ZONING DIVISION STAFF REPORT

May 11, 2022

Project Address: 231 South Pinckney Street
Project Name: Embassy Suites
Application Type: Approval for Comprehensive Design Review of Signage
Legistar File ID # [70889](#)
Prepared By: Chrissy Thiele, Zoning Inspector
Reviewed By: Matt Tucker, Building Inspection Director

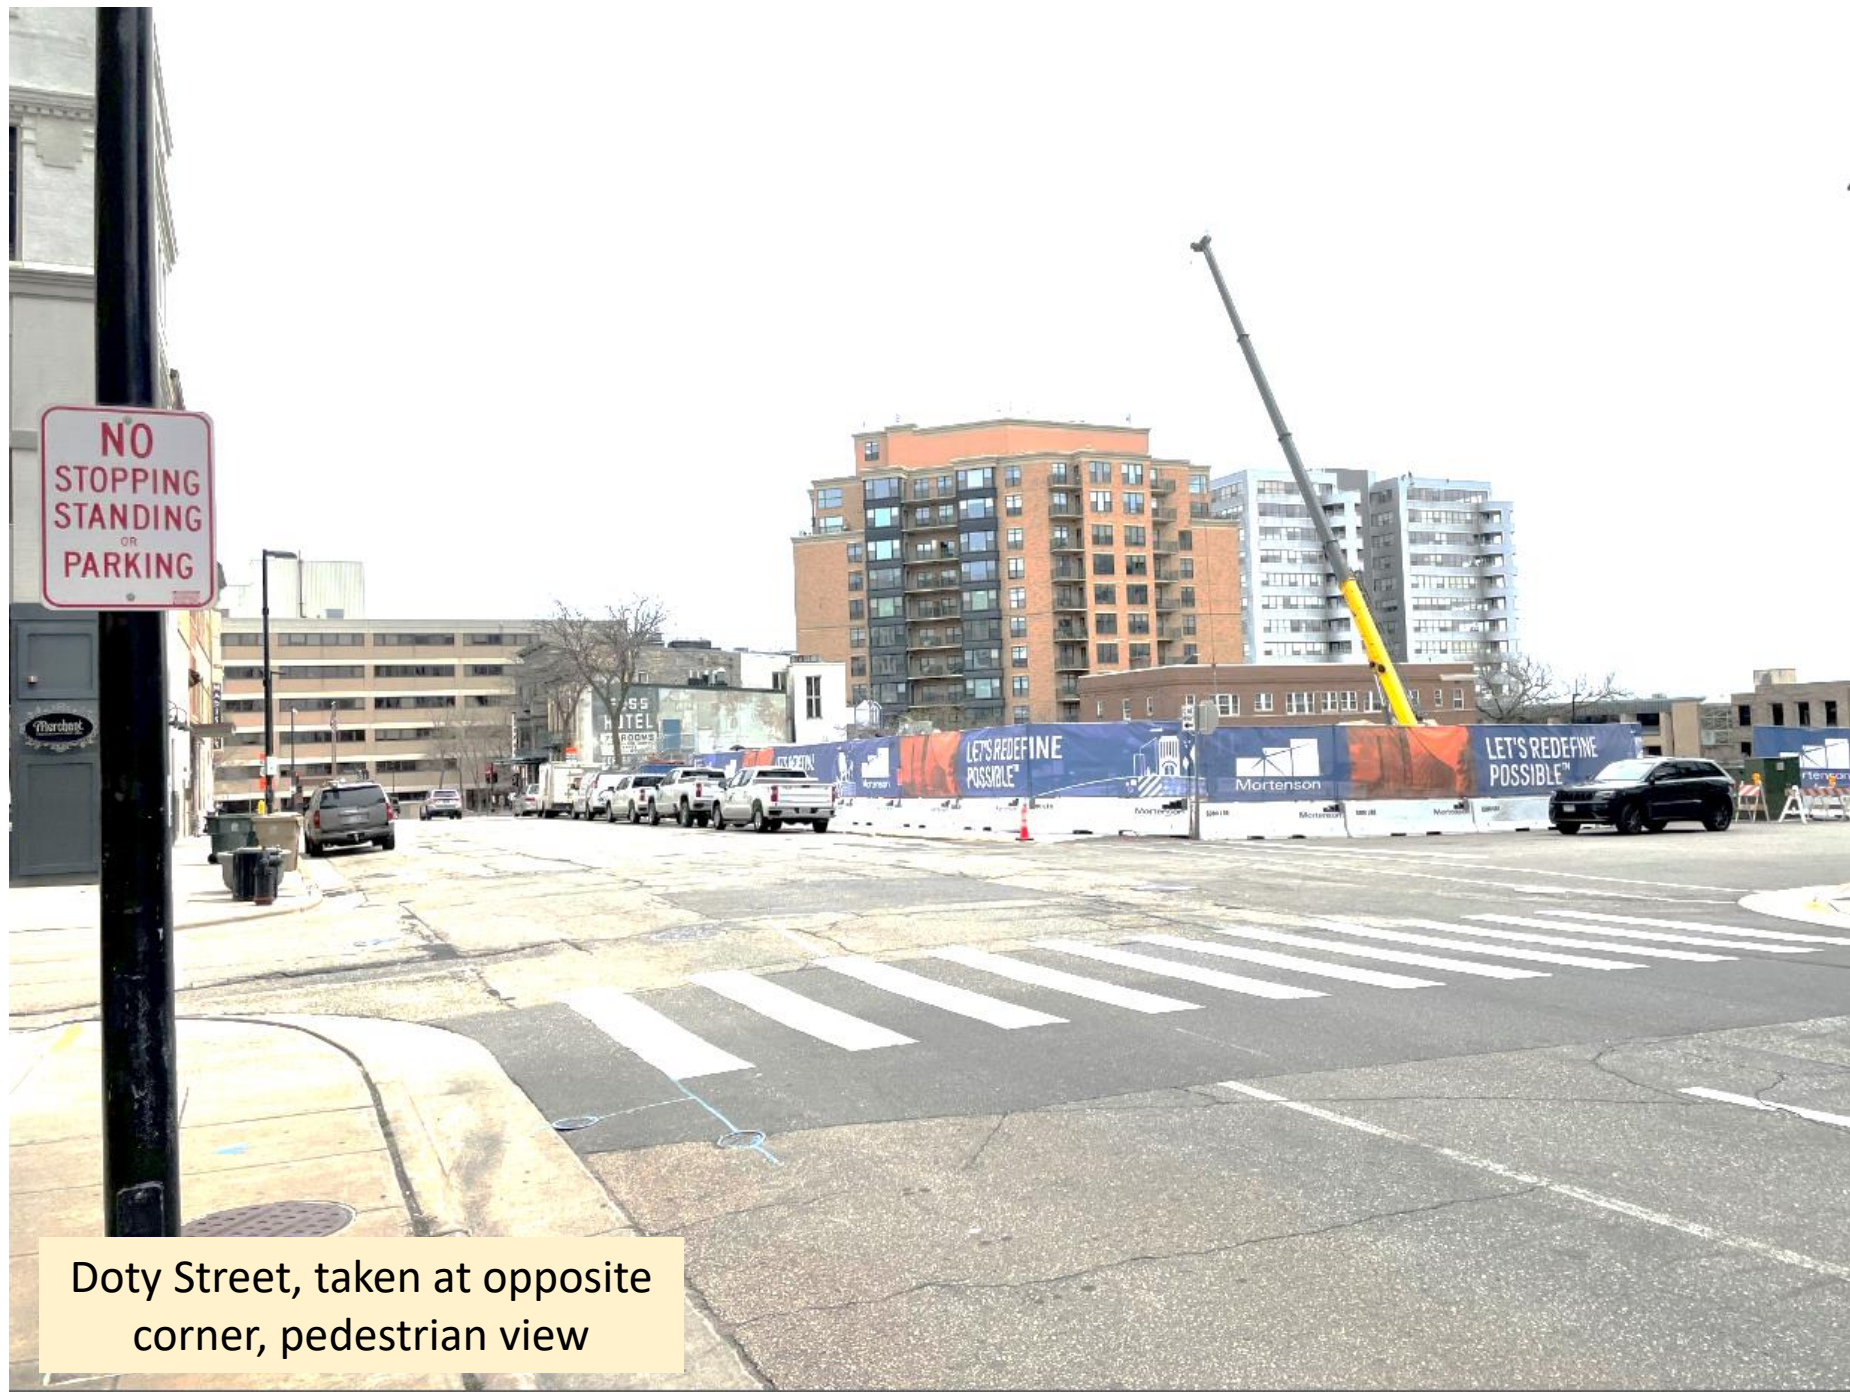
The provided renderings do not appear to match the elevations shown on the same page on the upper right corner. And though it is can be difficult to show an accurate representation for a project that is yet to be built, staff believes the provided renderings may not be accurate representations of the actual view of the signs, as pedestrians and motorists will view the site and signs. Instead the provided views appear to be elongated, making the sign appear farther away than it will actually be when viewed from the road. Recent photographs of the site have been attached to the Legistar file for this request.
